CUYAMA BASIN GROUNDWATER SUSTAINABILITY AGENCY STANDING ADVISORY COMMITTEE

Cuyama Basin Groundwater Sustainability Agency

Groundwater Sustainability Plan Update

Figure 2.2-28: 2008-2018 Average Well Measurements of Arsenic, ug/L

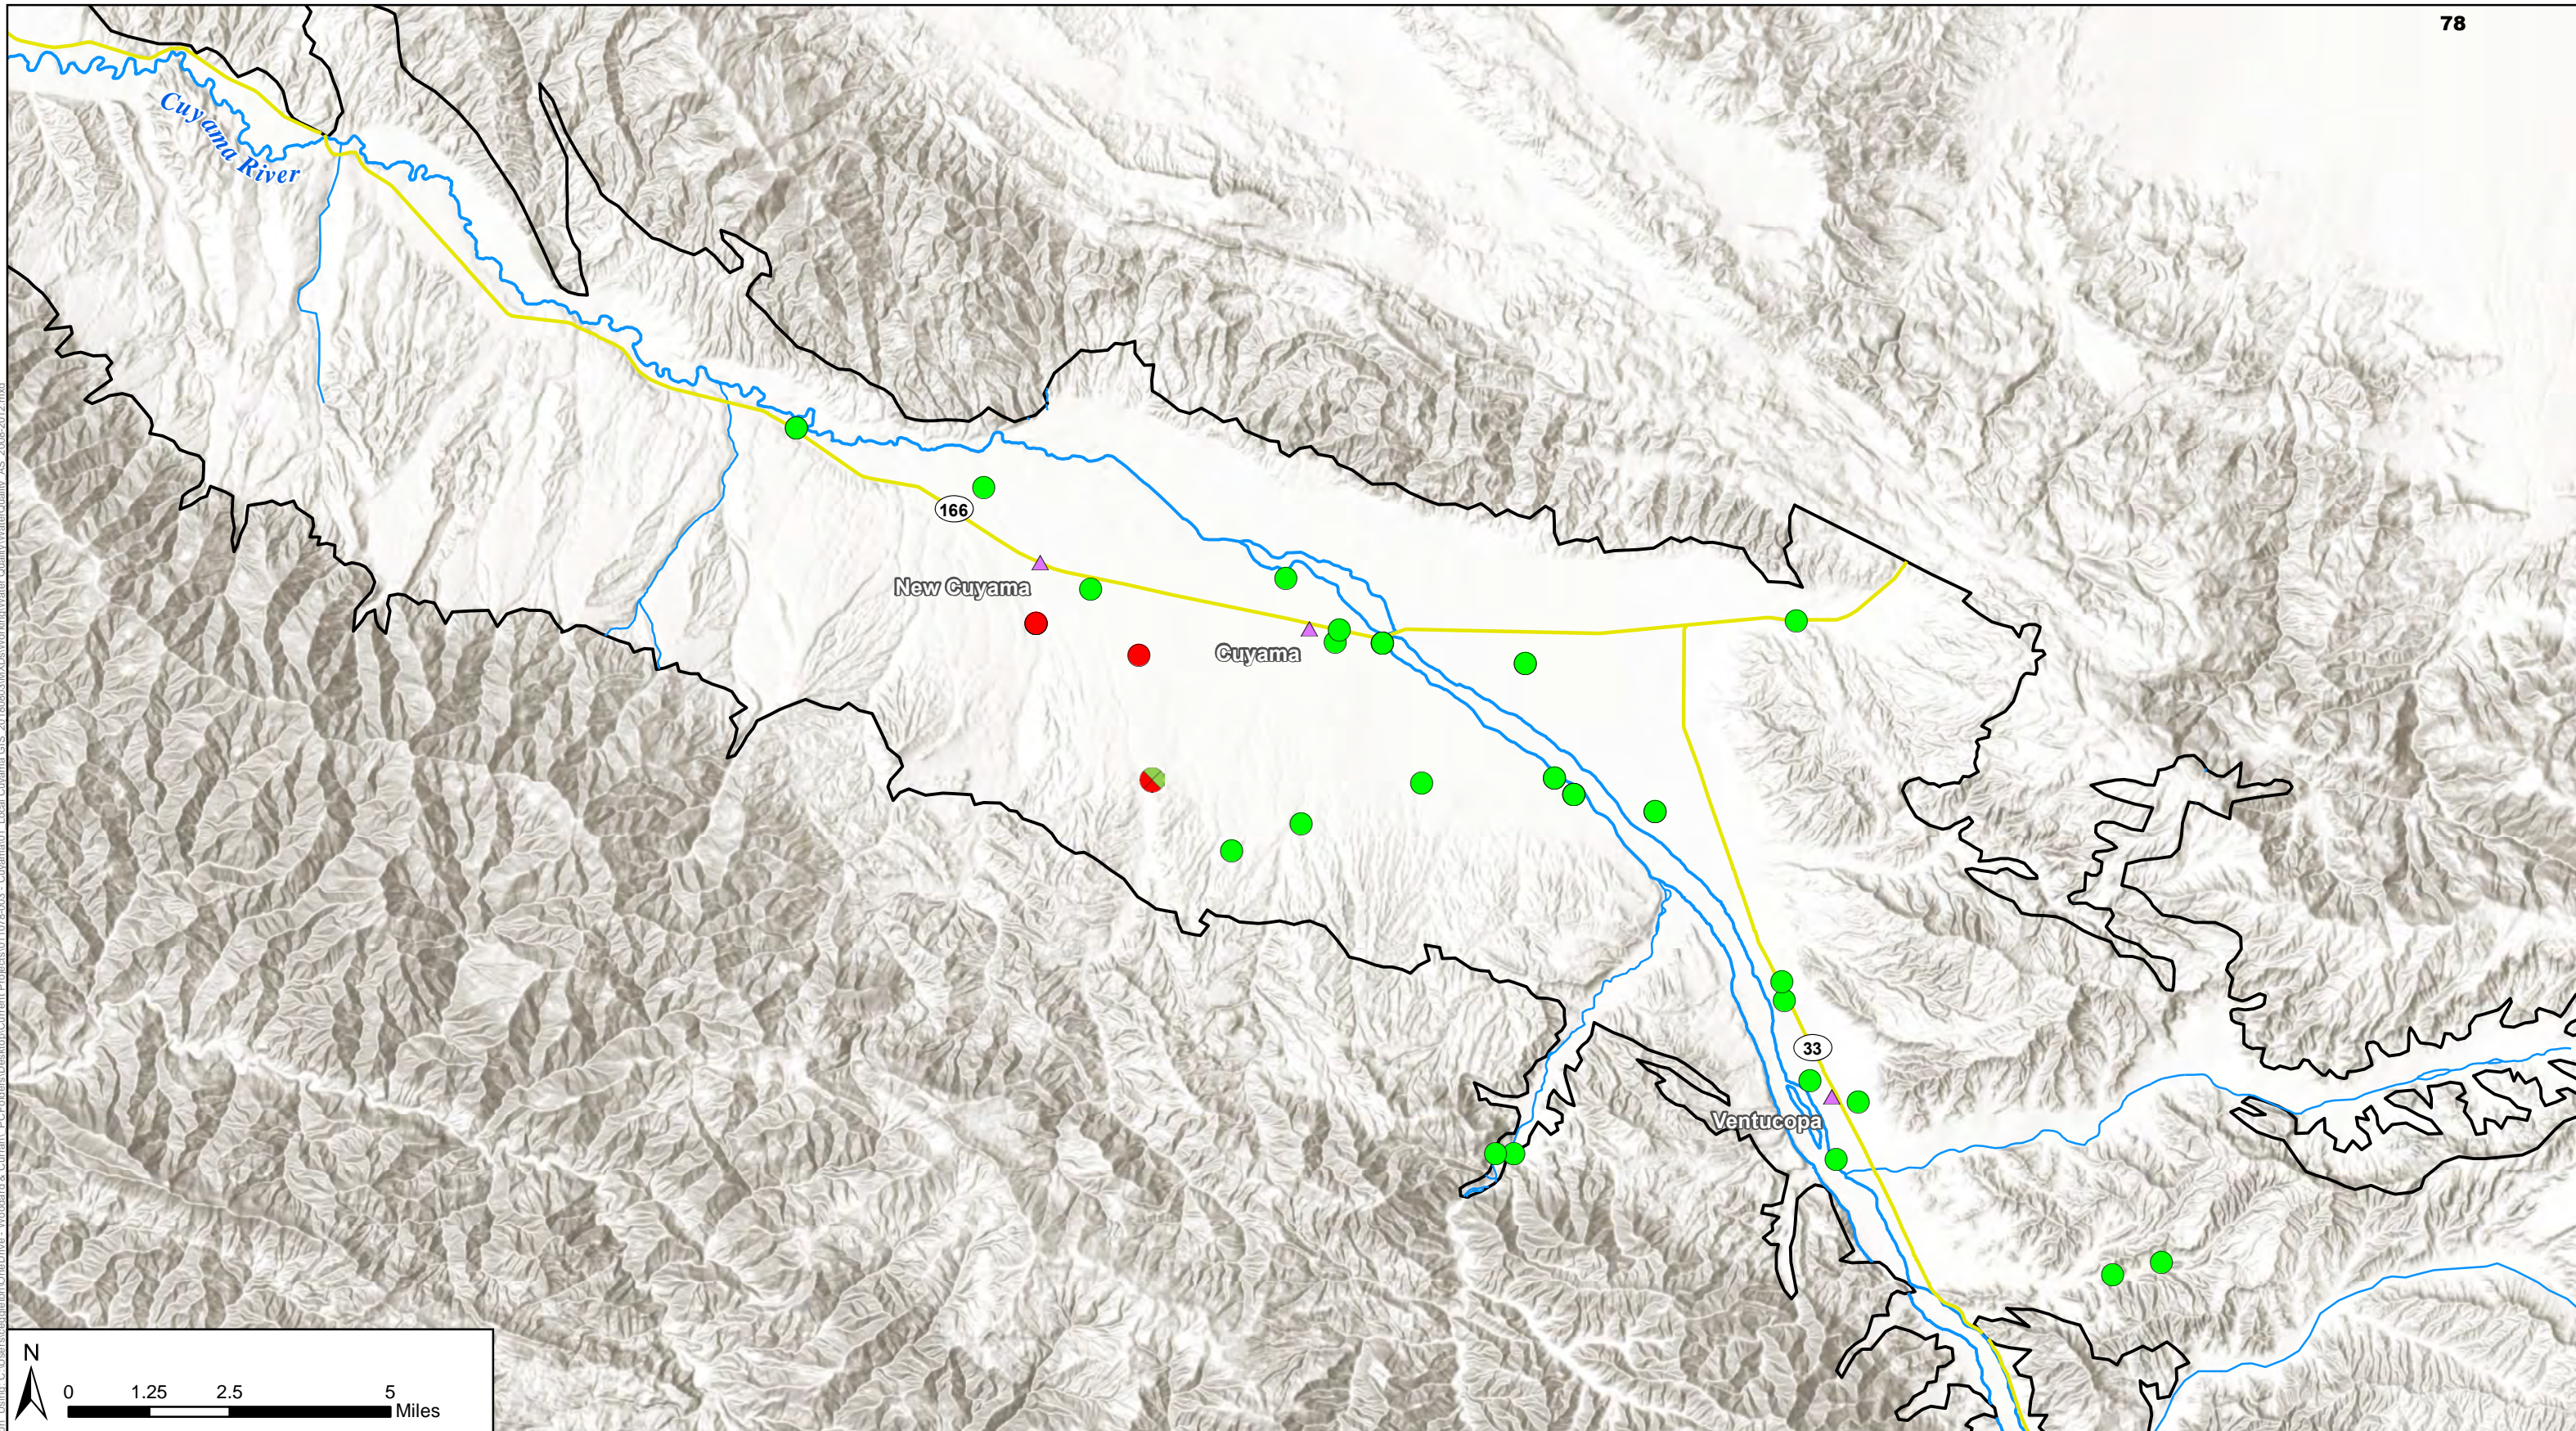
106	Cathy Martin	County of San Luis Obispo	2.2.7 Data Analysis			Figure 2.2-28 shows that the	Figure 2.2 28 shows arsenic measurements from 2008-2018. Data was not available prior to this time period in significant amounts. Figure 2.2 28 shows arsenic measurements were below the MCL of 10 ug/L where data was available. Suggest adding number of samples, ## samples out of ### total samples	Text has been revised for clarity.
107	Cathy Martin	County of San Luis Obispo	Figure 2.2-31				Place label on figure (Ballinger, Quatal, and Apache Canyons)	These are labeled on Figure 2.2-1
108	Cathy Martin	County of San Luis Obispo	2.2.7 Literature Review	Bullet List		97% of samples had concentrations greater than	Is this the MCL for each concentration? If so, please add the MCL in the bullet point	These are not the MCL. No change needed.
109	Matt Young, Matt Scrudato, & Fray Crease	Santa Barbara County Water Agency	General				This section as a whole requires significant revision. The description of wells needs to be revised to be clear what entity conducted the monitoring, not what database W&C gathered the data from. For a discussion of SBCWA monitoring programs in the basin, the SBCWA contract with the USGS, and its relationship to CASGEM, please contact Matt Scrudato. This section contains minimal analysis of groundwater conditions, just reporting of selected hydrographs, with little explanation or interpretation. The water quality section is confusingly structured and incomplete. Finally, although we understand the time sensitivities in preparing the GSP by spring 2019, it would save reviewers quite a bit of time if a technical editor or senior W&C staff member reviewed these sections prior to distribution.	The section has been revised for clarity.
